June 19, 2014

**Subject: Solar Spirit 4 Solar Project
Proposed Technical Project Changes**

H341764-0000-07-124-0024, Rev. 2

Attachment 1 Original Site Plan

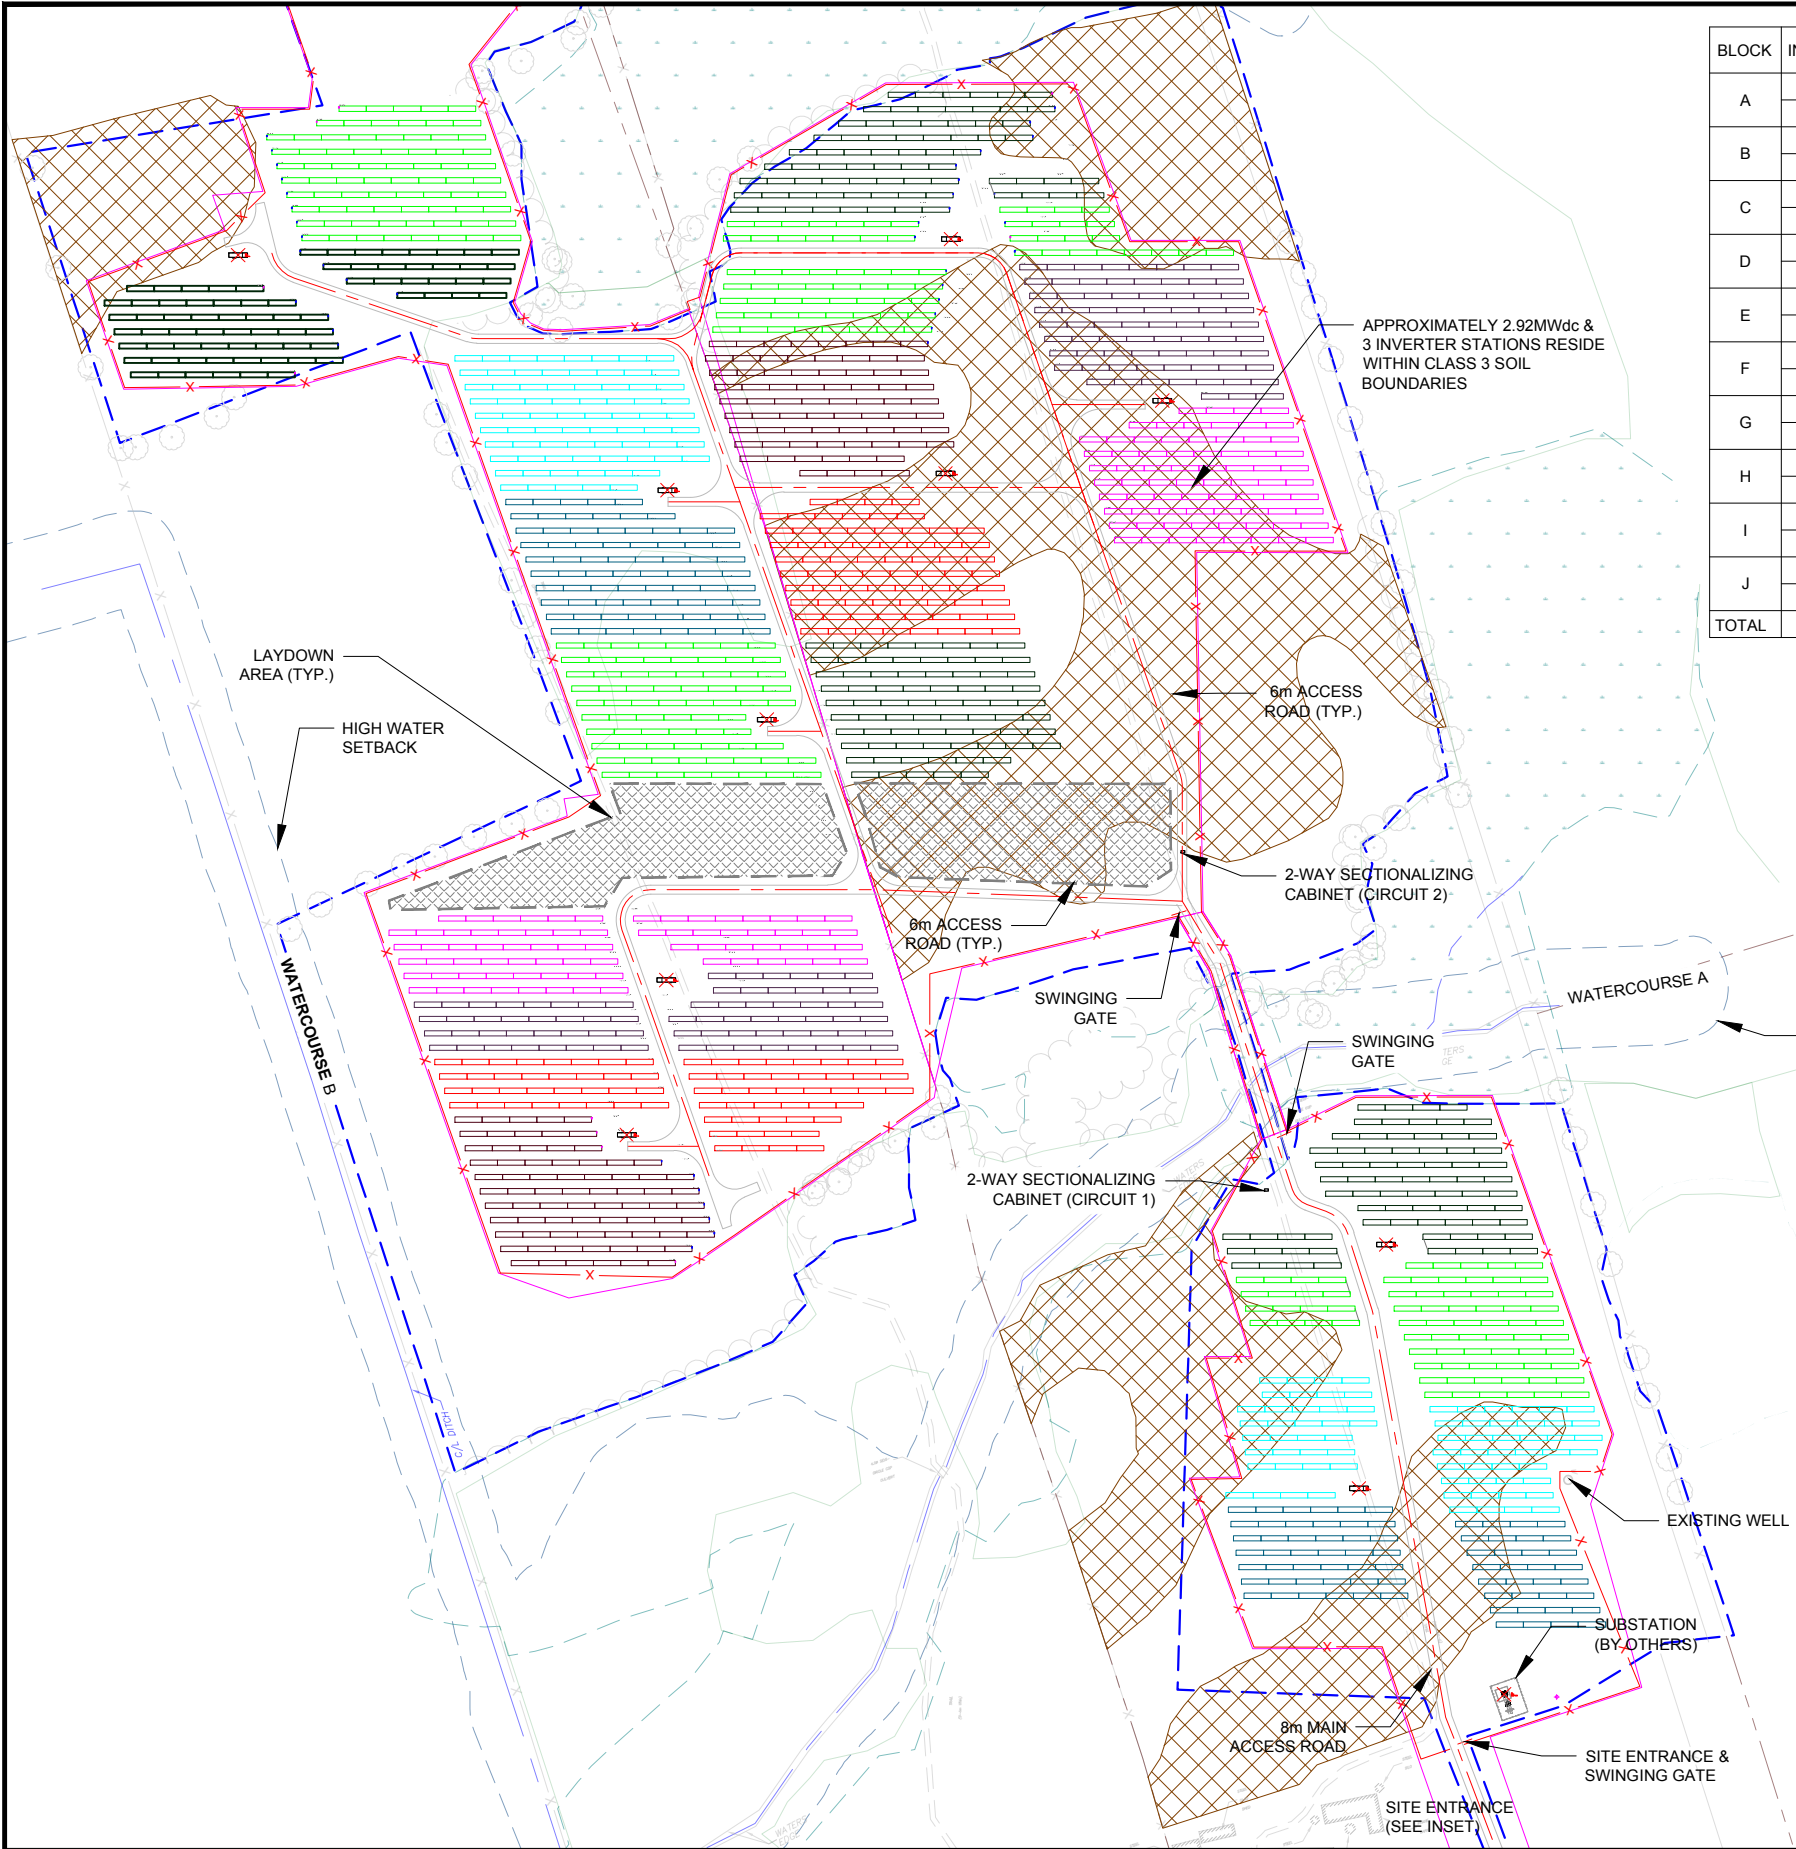
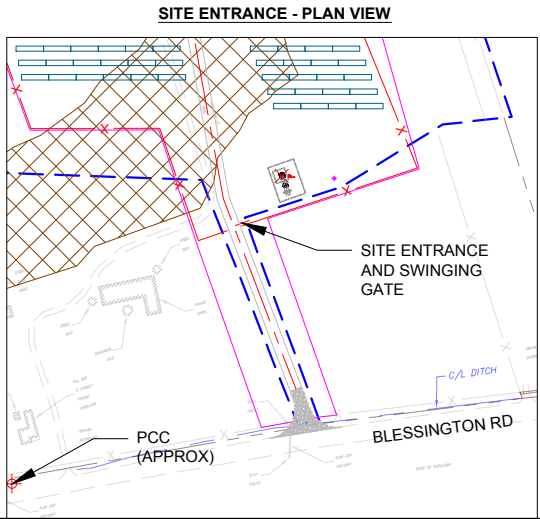
The proposed changes to the Project requiring an amendment to the REA includes firstly, the change in the internal alignment of roads, fencing, and solar panels from that shown in the original site plan of May 22, 2013 (Attachment 1) and secondly the change in the inverter model and associated change in sound power levels.

Attachment 2 contains the revised site plan, incorporating the necessary re-alignment of the access roads, fencing and solar panels, though, there has been no change to the design of the access road itself (i.e., road width, materials, construction methodology). Furthermore, there are no changes to the overall Project location boundary or any identified setbacks from water body or significant natural heritage features. All mitigation identified in the original REA application (e.g., sediment and erosion controls during construction, stormwater management measures) remain valid and will be applied or modified as necessary for the revised internal alignment of roads and solar panels.

The site layouts identified in the following reports are replaced with the site layout contained in Attachment 2:

- Executive Summary – Figure 2.1 – Site Layout Plan
- Construction Plan Report – Appendix A: Site Layout

- Design and Operations Report – Figure 2.1: Site Layout Plan
- Natural Heritage – Environmental Impact Study – Appendix A: Site Layout and Significant Natural Heritage Features
- Water Body – Environmental Impact Study – Appendix A: Site Layout
